Access Compliance Report

Public Rights-of-Way

Intersection ID: 47969	Main Street: HAWK_SHADOW_LN	Cross Street: TURNING_HAWK_RD	Location: SE
ADA ID: A27720F7750B	Ramp Type: PerpDiag	Initial Pass/Fail: Fail	Overall Compliance: No
			Severity Score: 21.25

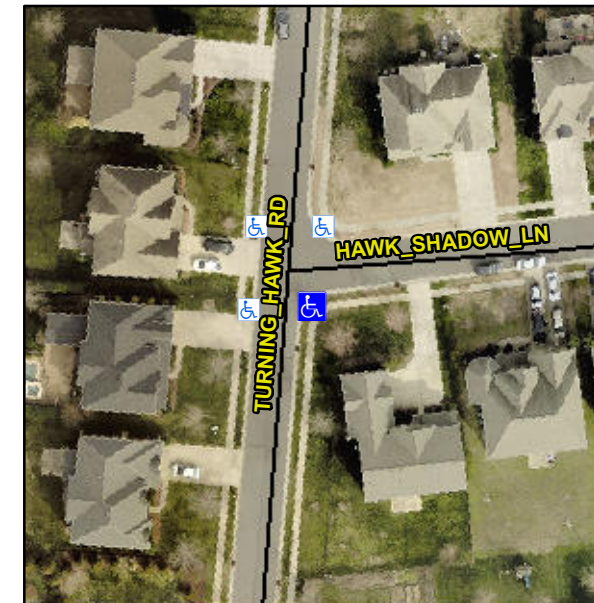
Not Found, R304.5.1, R304.2.2

Compliance	Description	Data	Compliance	Description	Data
N/A	Ramp Length (in)	49.0	No	Ramp Slope (%)	8.8
No	Ramp Width (in)	47.0	Yes	Ramp XSlope (%)	1.0
N/A	Flare Type LT	N/A	N/A	Flare Type RT	N/A
N/A	Flare Slope LT (%)	N/A	N/A	Flare Slope RT (%)	N/A
N/A	Flare Traversable LT?	N/A	N/A	Flare Traversable RT?	N/A
N/A	Landing Length (in)	N/A	N/A	DWS Provided?	N/A
N/A	Landing Width (in)	N/A	N/A	DWS Contrast?	N/A
N/A	Landing Slope (%)	N/A	N/A	DWS Length (in)	N/A
N/A	Landing X Slope (%)	N/A	N/A	DWS Full Width?	N/A
N/A	Landing Curb? (Y/N)	N/A	N/A	DWS Offset (in)	N/A
N/A	Shared Landing?	N/A			
N/A	Gutter Ponding?	N/A	N/A	Gutter Slope (%)	N/A
N/A	Gutter Lip Ht (in)	N/A	N/A	Gutter X Slope (%)	N/A
N/A	Painted X Walk1?	No	N/A	Painted X Walk2?	No
	X Walk 1 Direction	To NE		X Walk 2 Direction	To NW
N/A	X Walk 1 Width (in)	N/A	N/A	X Walk 2 Width (in)	N/A
	X Walk 1 Slope (%)	1.3		X Walk 2 Slope (%)	3.4
	X Walk 1 X Slope (%)	4.0		X Walk 2 X Slope (%)	1.9

Remove & Replace Curb Ramp With Two New Directional Ramps or Equivalent.
